TECHNICAL EVALUATION
OF
FEASIBILITY STUDIES
FOR
JRAGUNG DAM
AND
NGRAMBAT DAM

Subject: Technical Evaluation of Jragung and
Ngrambat Dams, Jratunseluna Basin,
Indonesia

PART 1
JRAGUNG DAM

FIGURE 1
GENERALIZED GEOLOGY
JRAGUNG DAMSITE

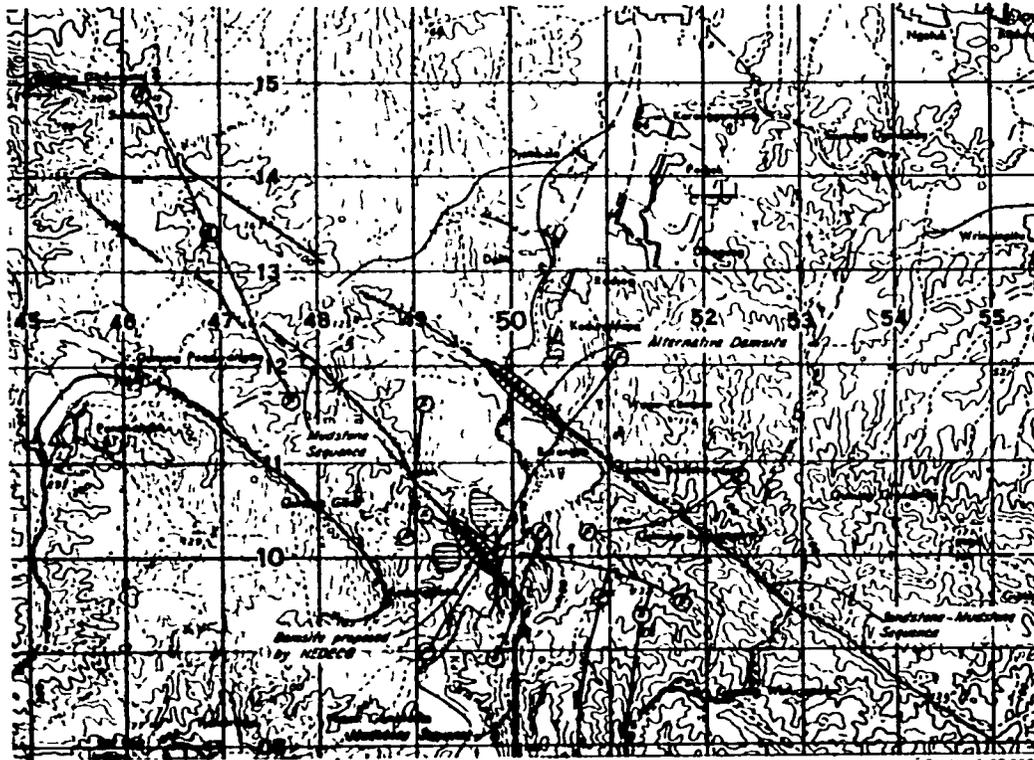
The generalized geology for this site is shown on Plate III-1.

This site has the same sequence of beds as the NEDECO one with approximately the same attitude. The regional geology map developed by NEDECO shows a small offset across a fault under the river and a high angle thrust fault running parallel to the bedding. From our regional geological studies, there appears to be no evidence for the latter. The topographic, geomorphological evidence suggests that much less distortion has occurred at and around this site than at the site selected by NEDECO. This is suggested by no apparent lineations and no change in the strike of the ridge.

FIGURE 2
GENERALIZED SECTION OF ABUTMENTS
JRAGUNG DAMSITE

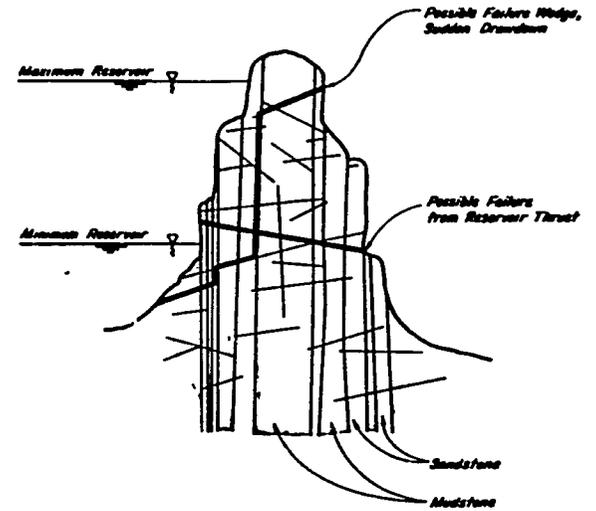
The abutments are crisscrossed by surfaces along which relative movement has occurred and formed thin seams of soft weak clays. Some of these are essentially vertical, others are essentially horizontal. It seems not only possible but quite likely that some of the rock masses bounded by these seams will be unstable under reservoir operation conditions, especially since the condition of a drained reservoir after sudden drawdown will prevail for long periods of time. In fact, the simple question of stability against downstream movement of the abutment resting on such a horizontal seam requires study, since the abutment is

rather thin; locally there may be additional mass needed. A typical abutment section of the geology is shown on Figure 2 of Plate III-1.

FIGURE 1
PRELIMINARY DESIGN OF JRAGUNG DAM
PREPARED BY HEDECO

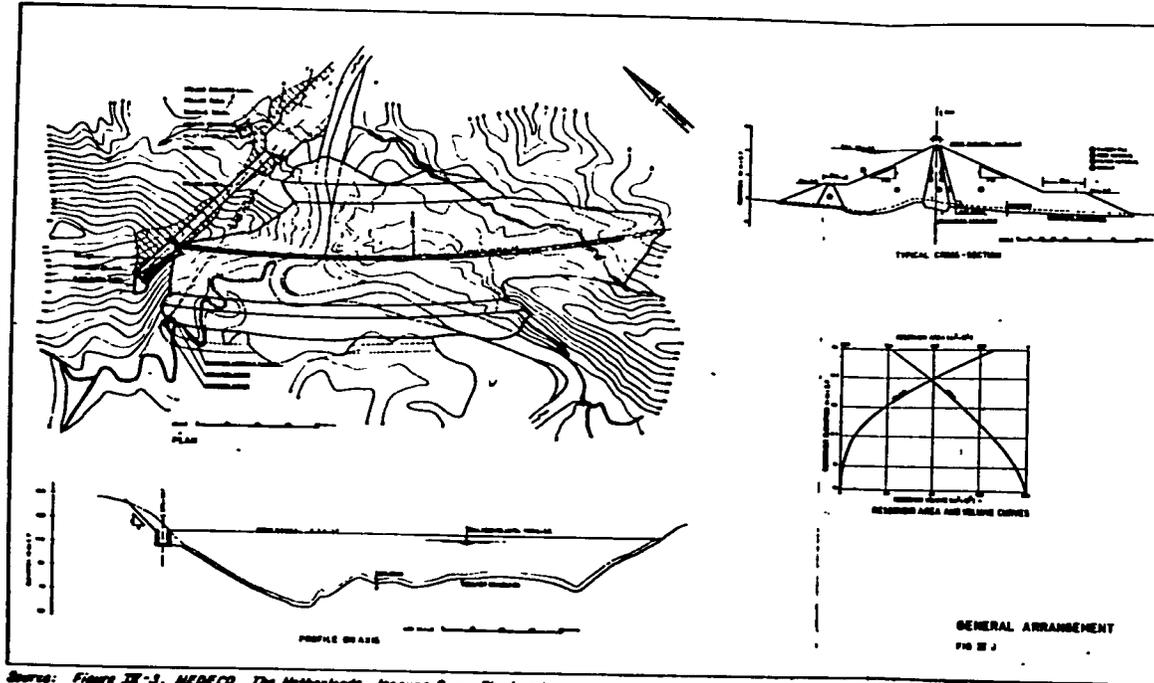
Possibly the biggest questions remaining relate to the materials available for the construction of the dam. However, there is some doubt that the dam section proposed in NEDECO's Feasibility Report is the most desirable design. That dam section proposed has a central core with a cutoff grout curtain. In light of the critical foundation conditions, a sloping core with an upstream blanket might be more appropriate.

A section for the sloping core dam with an upstream blanket is shown on Figure 2 of Plate V-1.

FIGURE 2
POSSIBLE GENERALIZED GEOLOGIC SECTION
ALONG AXIS OF DAM SELECTED BY NEDECO

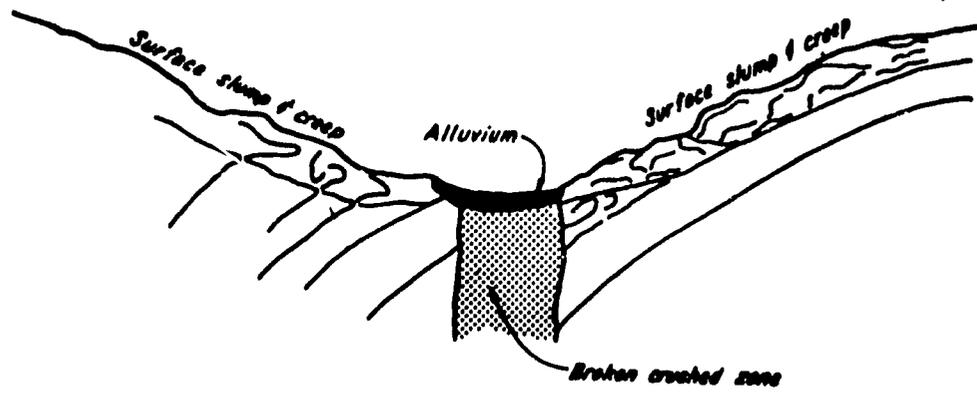
We believe the foundation conditions for the damsite selected by NEDECO present problems which are so serious that consideration should be given to moving the damsite to an alternative site, which is located approximately 1 kilometer downstream. Both sites are underlain by a predominantly mudstone sequence with some interbeds of sandstone. At the present site, however, the core samples indicate there is a crushed zone of pervious material that underlies the river. This zone is approximately 30 meters wide and more than 50 meters deep, and it follows approximately the alignment of the river.

This crushed zone will create significant leakage problems unless it can be effectively cut off. Grouting will be difficult, and the results uncertain; furthermore, structural damage to the foundation could result from piping unless the foundation leakage can be controlled.

In addition, the strength of the crushed material in this zone is very poor. Therefore, the embankment slopes will have to be flattened to provide for a stable condition along a failure surface through this zone in the foundation.

FIGURE 3
RANGE OF SECTIONS POSSIBLE
USING DIRTY GRAVELS AS AT NGLANJI

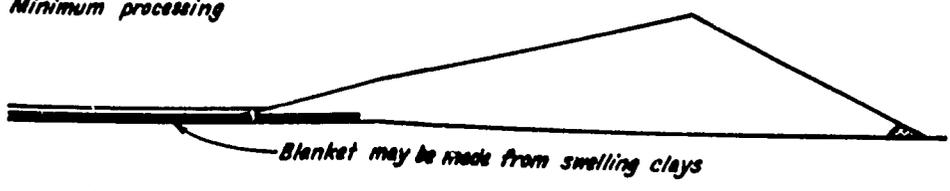
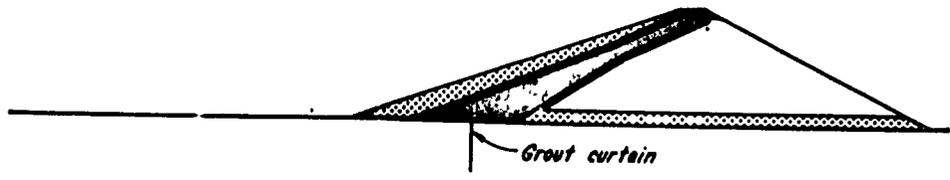
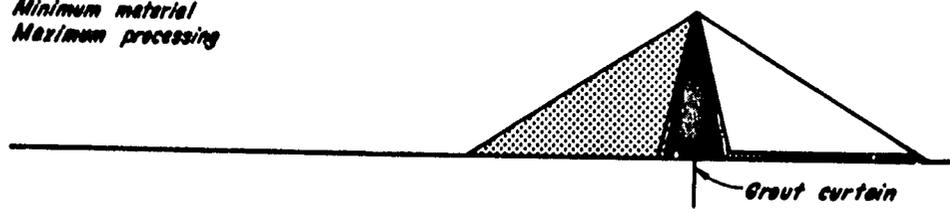
The decision is one of cost. At one end of the spectrum of possible sections is an unzoned homogeneous section except for a downstream toe drain; this will be a section with very flat slopes and the maximum amount of material, but with the minimum processing. At the other extreme is a section with vertical central core and an upstream shell all pervious; this will be a section with minimum material, but half of it will require processing.

Between the two extremes is a section with an inclined core on a filter drain, and a thin pervious upstream shell. Such a section will have an upstream pervious shell equal in volume to the coarse fraction from which the fine fraction had been removed to produce an impervious core of suitable thickness. The majority of the section will be downstream and consist of the unprocessed gravels; the total embankment volume will be less, and the upstream slopes steeper than those for the unzoned dam because of the free draining shell and the drain underlying the core. These various dam sections are shown on Figure 2 of Plate 1.
